REQUEST FOR INFORMATION (RFI)

PROJECT :	BKK2	R.F.I. NO. :	523213-01-RFI-AR-0026
TO :	CTA	ATTENTION :	CTA
SUBMITTED DATE:	19-Jan-26	NEED REPLY BY DATE :	26-Jan-26

SUBMISSION OF :	<input checked="" type="checkbox"/> Q&A	<input type="checkbox"/> Drawing	<input checked="" type="checkbox"/> Document	<input type="checkbox"/> Others (as specified below)
SUBJECT : Request for Information - Reduce the Thickness of Glass Block in the Curve Wall from 12.7 mm. to 10.0 mm.

12.7 MM.GLASS BLOC +METAL STUD PROWALL ELEPHANT NO.24 C74U76 +
50MM.THK NOIZEBLOC

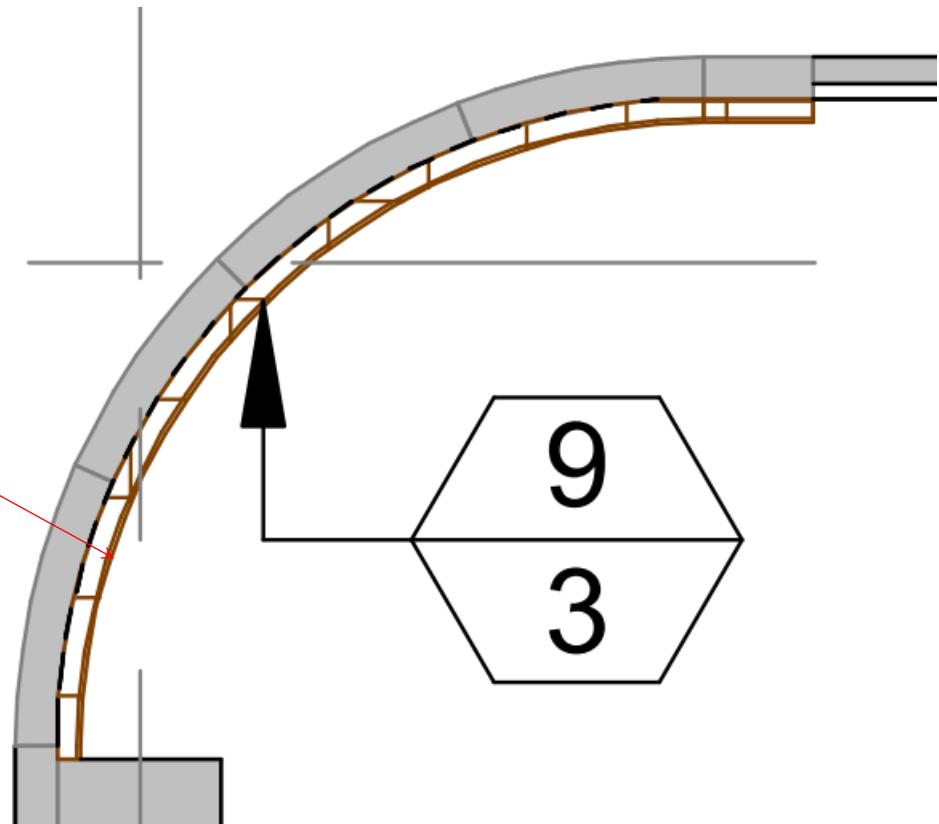
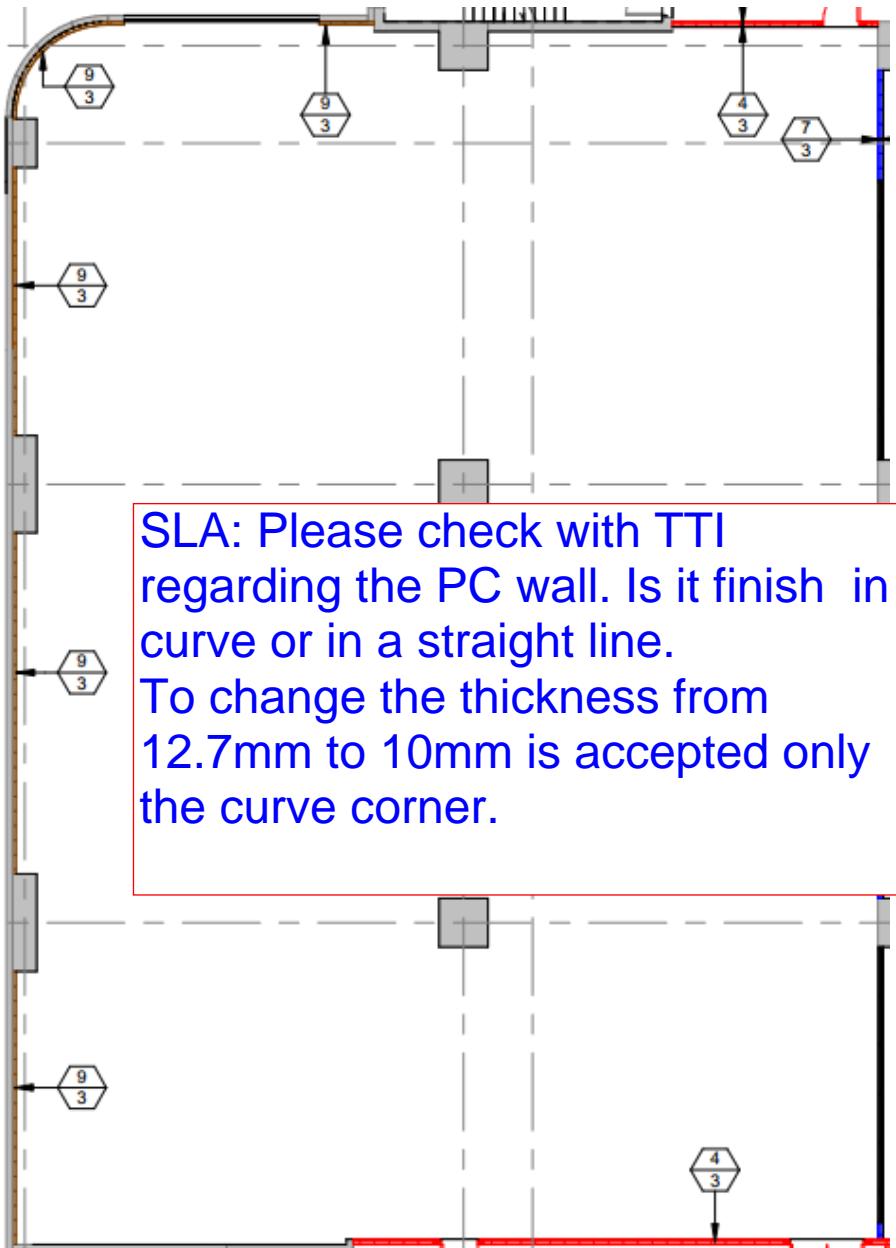
GAA Want to ask for confirmation about wall thickness to do the curve wall at edge of the building that can we reduce the thickness of the wall from 12.7 mm. to 10.0 mm. thickness

for easily to do the curve wall smoothly, you can check the details of the material in attached file

Aurecon to confirm GAA's request to reduce the thickness to ensure a smoother finish.

SLA: Please refer to the notes in the attached markup.

contractor to work together with TTI to confirm

at the curve line
